**Submission to Craigieburn West Precinct Structure Plan
1340, 1390, 1430 & 1480 Mickleham Road and 665 Craigieburn Road, Craigieburn
(Properties 28, 29, 30, 31 and 34)**

Thank you for the opportunity to make a submission in relation to PSP 1068 – Craigieburn West Precinct Structure Plan [Draft for Public Consultation] (PSP) and accompanying planning scheme provisions.

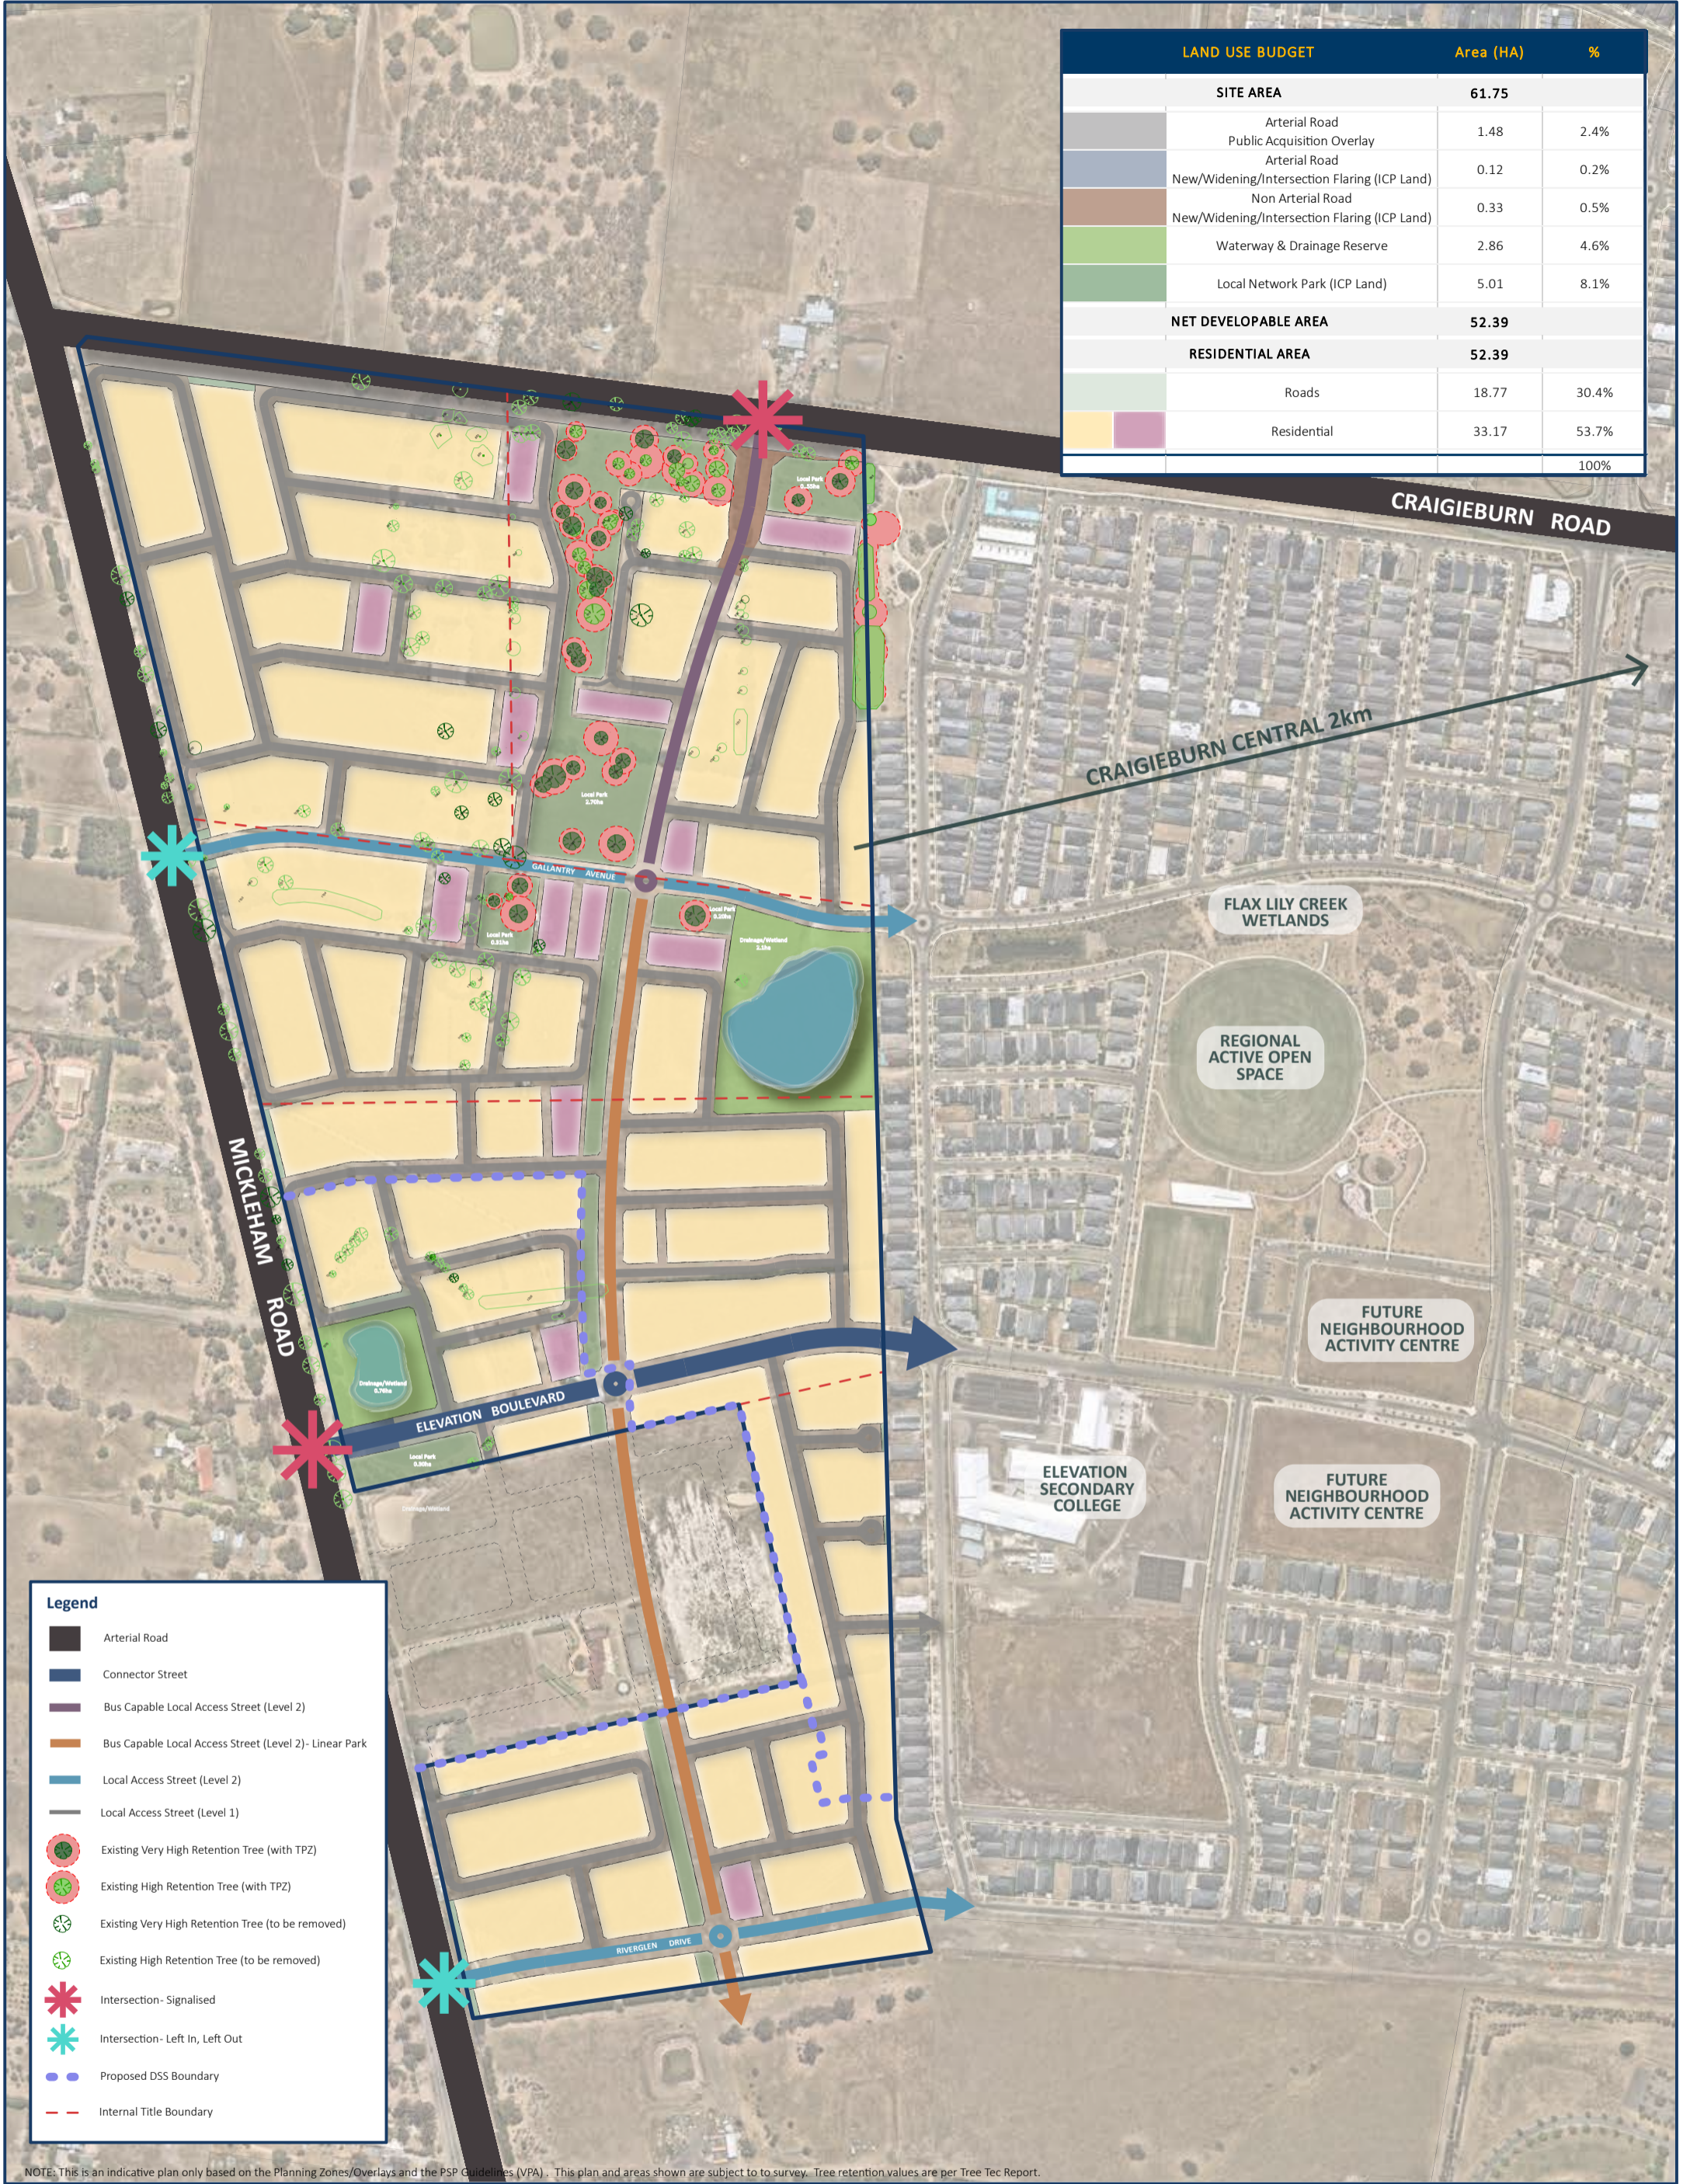
The Master plan has been informed by detailed onsite analysis and whilst generally consistent with the Place Based Plan in the PSP, there are some necessary departures.

As demonstrated by the attached Master plan there are other ways the land could be developed that still achieve significant scattered tree retention, which we request is further considered following exhibition of the PSP.

Our attached Master plan shows a very similar local park configuration to Plan 8, except for the location of the local park between Properties 31 & 32 (LP-14).

- Amend Plan 8 (Open space) of the PSP by altering the local open space distribution to be consistent with the attached Master plan.
- Amend the Property Specific Land Budget table to change the land areas of the local parks to match the areas shown on the Master plan attached to this submission, and to achieve a Public Land equalisation outcome across the Peet landholding.

Figure 5-1: Draft PSP Transport Plan (Nov 2020)

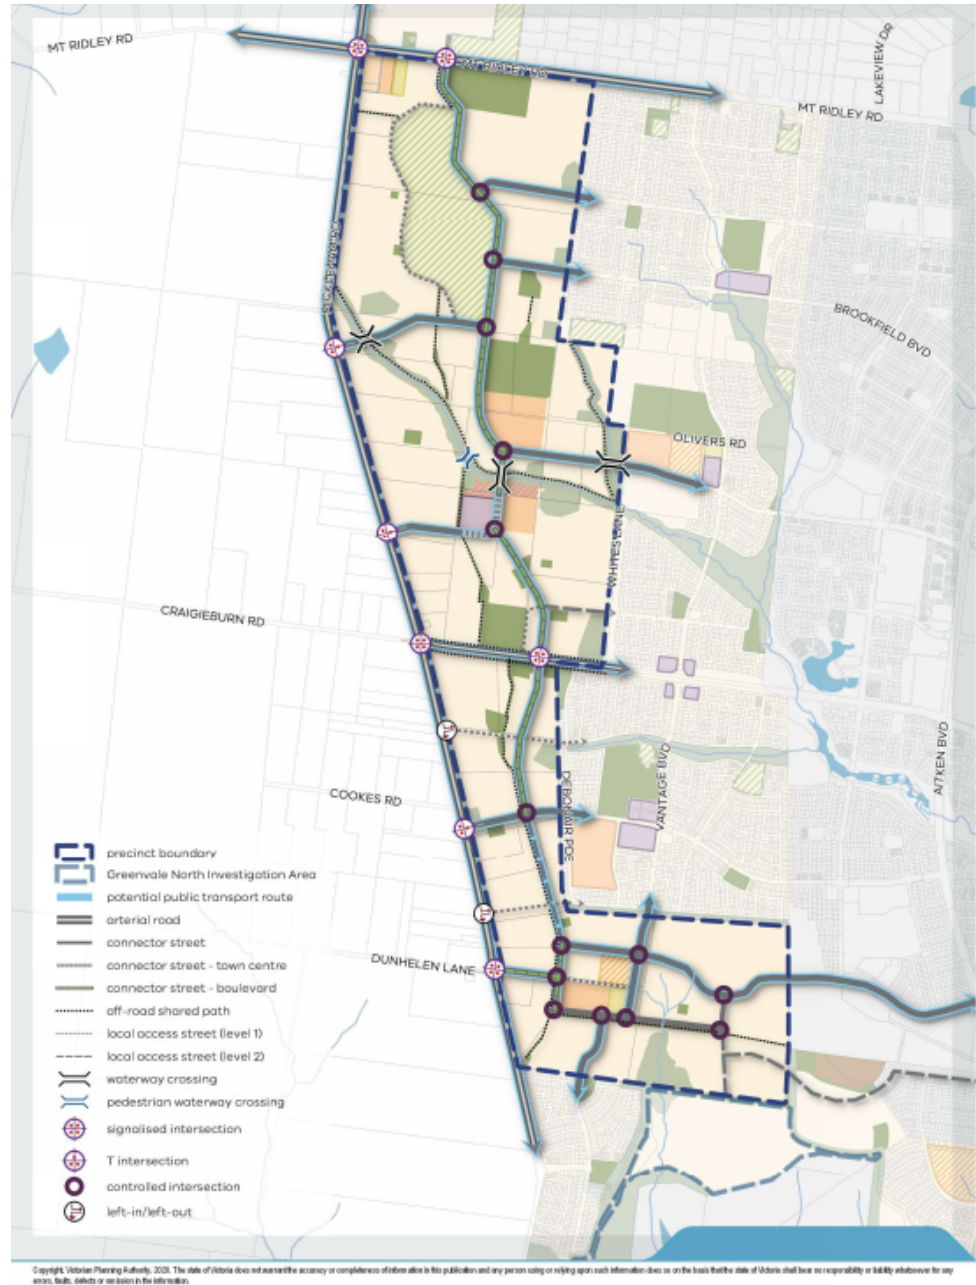
As shown in Figure 5-1, the Craigieburn West PSP will have a number of new signalised intersections on Mickleham Road with left in / left out access points generally between each set of signals.

It is noted that the east west roads, which will form the extensions of Gallantry Avenue and Riverglen Drive are identified in the PSP as Access Street Level 1 on Figure 5-2. This is inconsistent with their current designation as Access Street Level 2. The higher order classification of Access Street Level 2 is considered more appropriate, as it will allow a consistent cross section between the Aston community and the new Peet development. It is also noted that a downgrade of road classification is not typically appropriate when the traffic volumes increase towards the western end of both roads, due to the anticipated traffic from the Aston community.

The legend provided on the Transport Plan doesn't appear to accurately reflect the Boulevard Connector road type. For clarity the legend should be amended to match the line types shown on the Transport Plan.

- Downgrade of the north-south road between Craigieburn Road and Elevation Boulevard from a Boulevard Connector to bus capable Access Street Level 2
- Change classification of Gallantry Avenue, existing and extension, to Access Street Level 2, as per the existing construction standard, the Craigieburn R2 PSP and the anticipated use.

- Change Riverglen Drive to Access Street Level 2, as per its existing construction standard, Craigieburn R2 PSP and the anticipated use.
- Update legend on the Road Network Plan to ensure all road types shown on the PSP plan are included and readily identifiable.

- Add a “Bus Capable Local Access Street Level 2 - Linear Park” road type, and any other specific road types required to accommodate the proposed Linear Park.

- Change wording in the legend from ‘controlled intersection’ to roundabout as per the OMG traffic assessment and standard practice to reduce future ambiguity.

Figure 5-3: Example of downgrading intersection priority

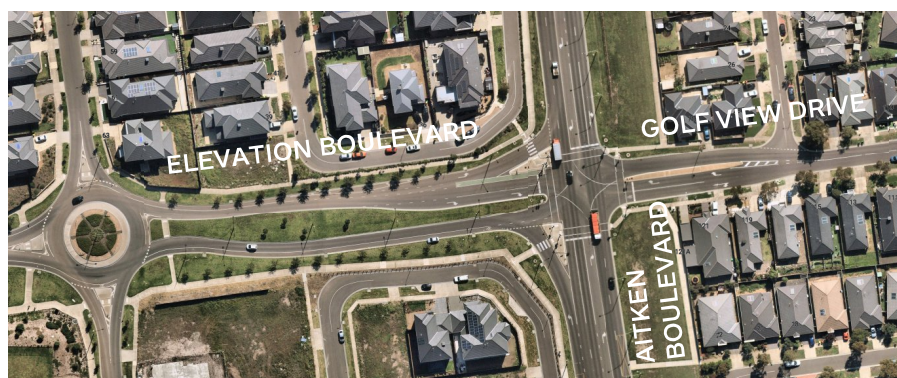
An example of how the intersection may be structured to discourage through traffic is provided locally at the intersection of Elevation Boulevard and Aitken Boulevard, as shown in Figure 5-3.

It is recommended that a similar treatment be undertaken at the Craigieburn Road / North South Road intersection. As this intersection arrangement will not fit into one of the VPA Benchmark Designs, a specific notation will need to be added to the Road Network Plan and associated section to achieve the desired outcome.

Figure 6-2: Proposed Bus Capable Access Street Level 2 Cross Section Adjacent Linear Park

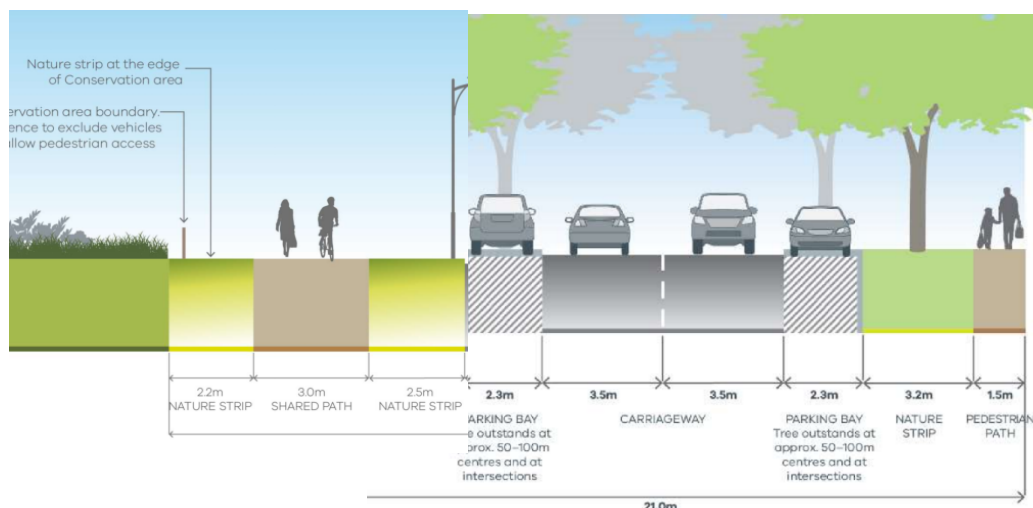
We would anticipate that the Access Street Level 2 Cross Section abutting the Linear Park would be amended, such that the footpath and verge adjacent the Linear Park were removed and replaced with the Linear Park including shared path. An example of how the cross section would look is shown in Figure 6-2.

- Cross sections for the adjacent arterial roads should be provided, as well as an updated version of the frontage road requirements.
- We support the addition of the Bus Capable Access Street Level 2.
- Include a cross section for a laneway.
- Include detailed cross sections of the Linear Park, particularly where it abuts a proposed road cross section, as shown in Figure 6-2.
